Additional North Dakota Game and Fish Correspondence

Badger Wind Farm Impacts Analysis and Offset Estimates

RE: Badger Wind Project, Logan and McIntosh counties, North Dakota

Figure 1. Results of NDGF local grassland assessment.

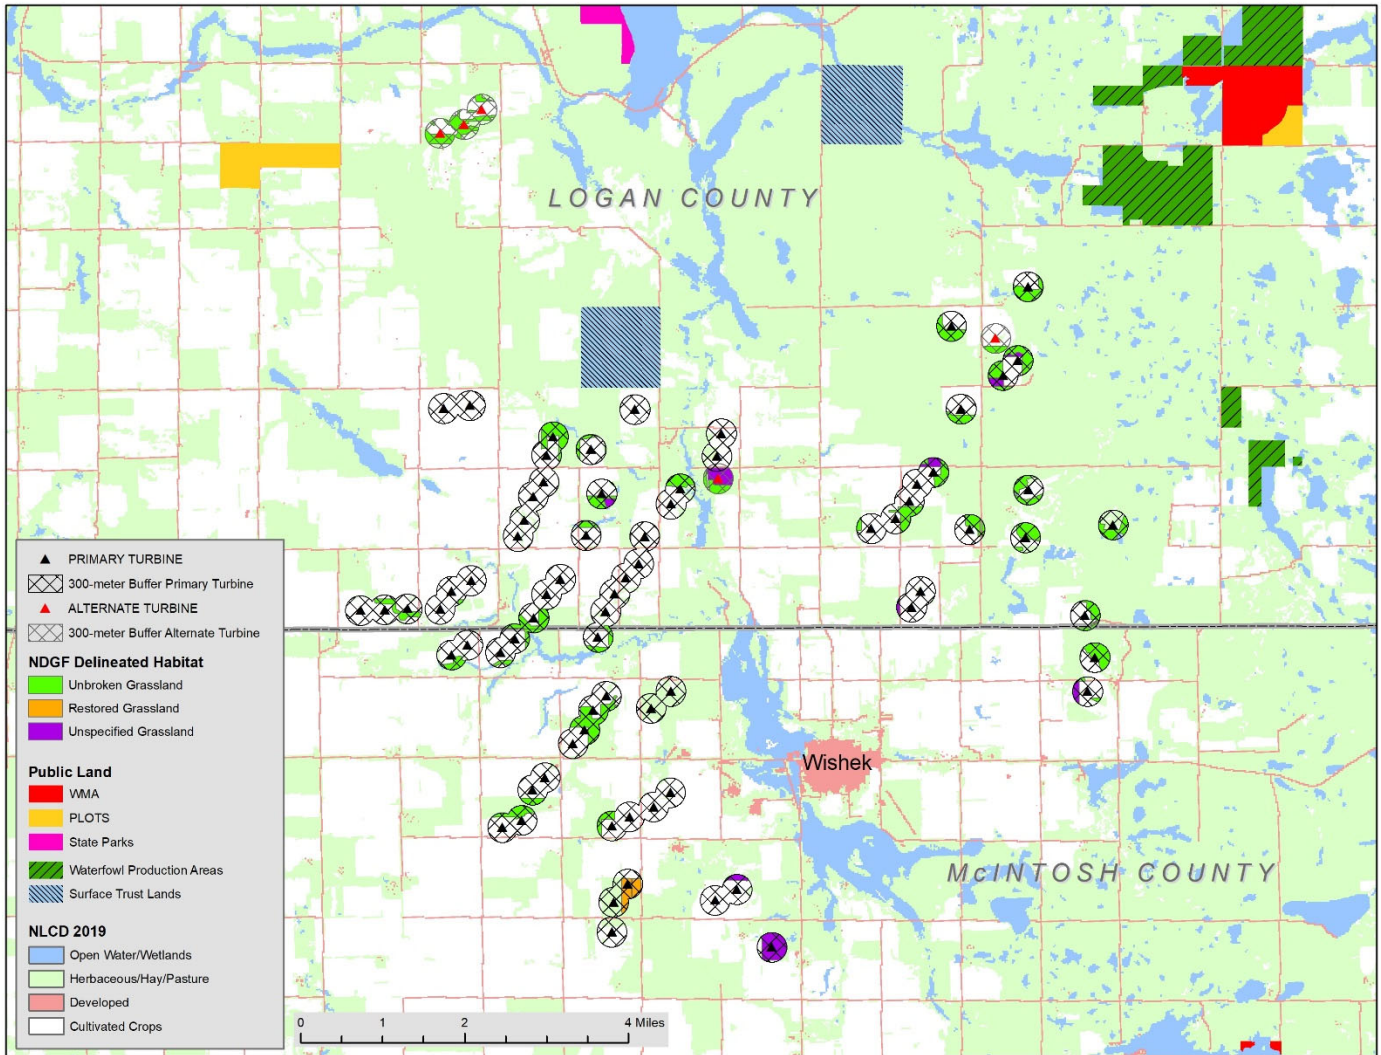
Great I will review. Just a super quick note in case this changes anything, in the attached document it states 52 primaries and 8 alts. Is that the number of turbines you've totaled to be impacting grasslands to a certain degree? Just want to make sure it adds up. 😊

Sorry for the delay in this. I see you emailed back in March, but I am only seeing this now... I am not sure how I missed it! I double checked with Sandy and the analysis is correct, with 74 primary and 5 alternate turbines. This was just an error in the text. I made the edit and am attaching it here.

Attachment 4. Chestnut-collared Longspur Model with original turbine layout

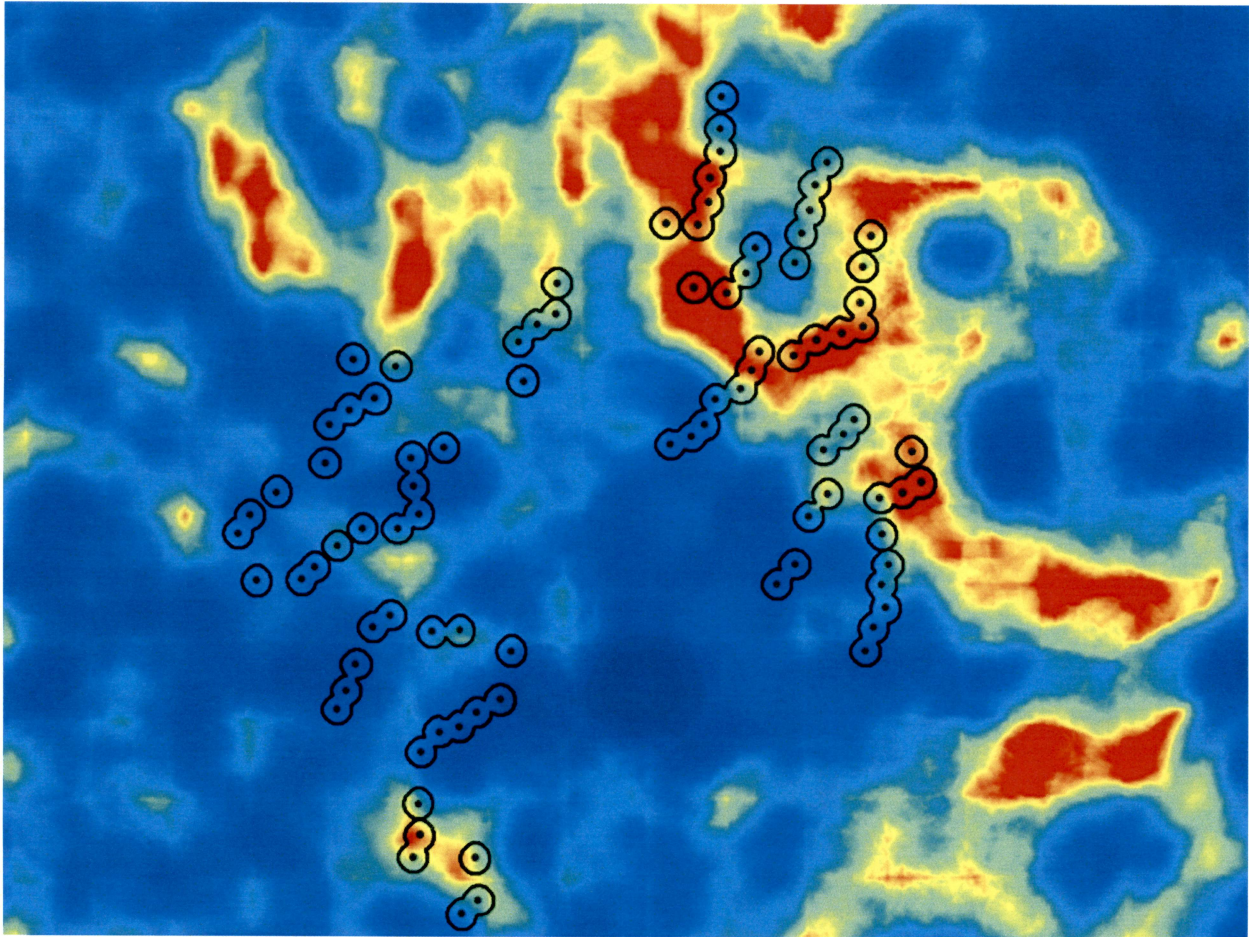
The North Dakota Game and Fish Department (Department) first learned of the proposed Badger Wind Project in early 2020. Many of the early discussions on the project centered around the Department’s serious concerns of the project boundary (Guidance Letter, Attachment 1). The area, specifically the northern part, has a considerable amount of unbroken, native prairie (Attachment 2). This habitat is essential for many rare and declining species, such as grassland dependent birds. These birds, our ‘canaries in the coal mine’, have shown “steeper, more consistent, and more geographically widespread declines than any other behavioral or ecological guild” (Knopf 1994). Breeding Bird Survey data collected from 1966-2015 show the state’s bird, the Western Meadowlark, declines approximately 1.25% each year. Once abundant throughout the state, the Western Meadowlark has lost over half of its population in North Dakota and is now considered rare in the eastern counties. Another example, the Chestnut-collared Longspur, has decreased by 86% since 1974 (Rosenberg et al. 2016) and is listed as a Species of Conservation Priority in the North Dakota State Wildlife Action Plan (Dyke et. al 2015) and is on the IUCN Red List as Vulnerable and is considered globally threatened. In 2020, the project layout provided to the Department had over 20 turbines being placed in unbroken prairie crucial to Longspurs in North Dakota (Attachment 3 & 4).

Attachment 6. Final turbine layout and habitat delineation

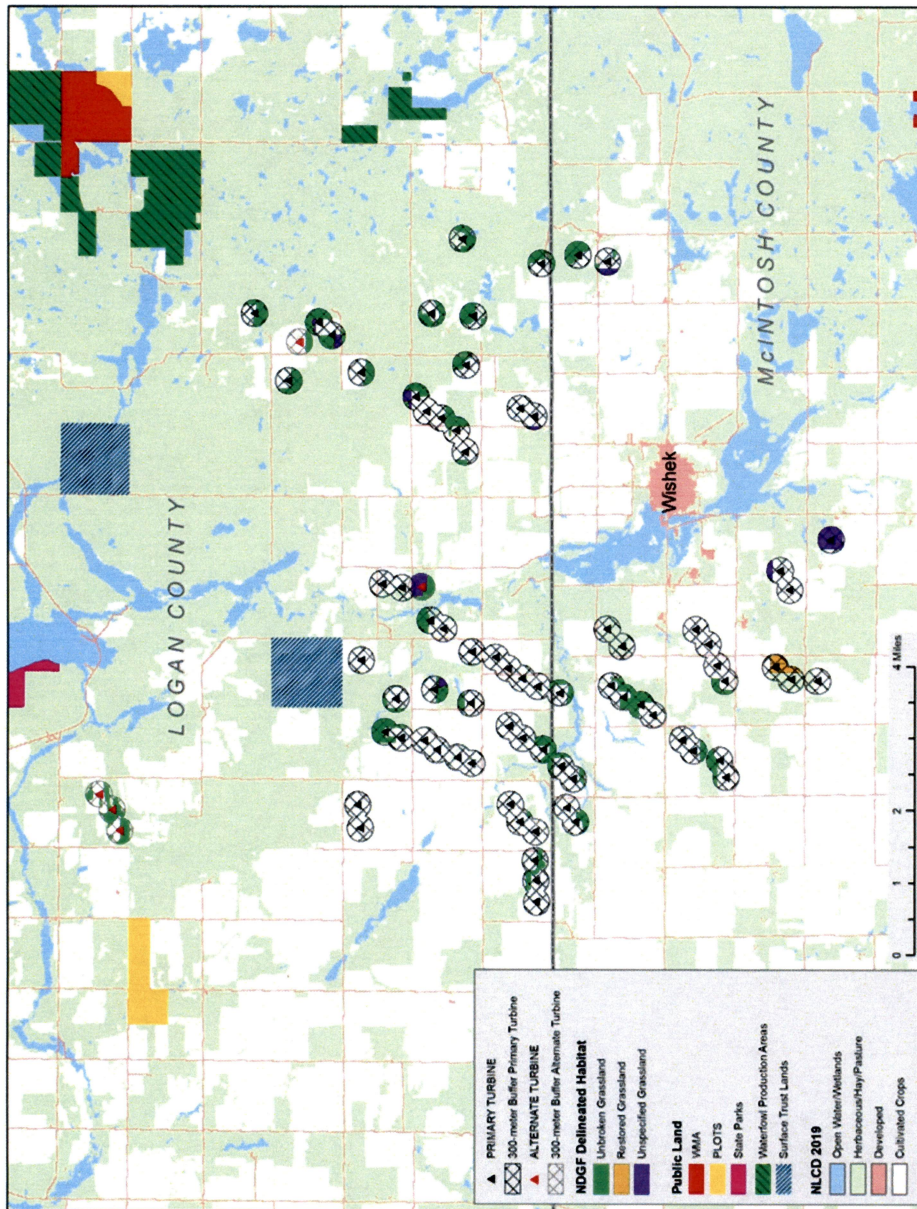
In February of this year, Badger provided an updated turbine layout. This new turbine layout is a great improvement from the original layout, with many turbines moved away from areas of important habitat. However, because the site originally selected for the project fell partially within a resource rich and sensitive area (Attachment 5a & 5b) and surrounded a vast amount of native habitats (both grasslands and wetlands), even with the changes made there are likely to be significant impacts to wildlife and the habitats they depend on (Attachment 6).
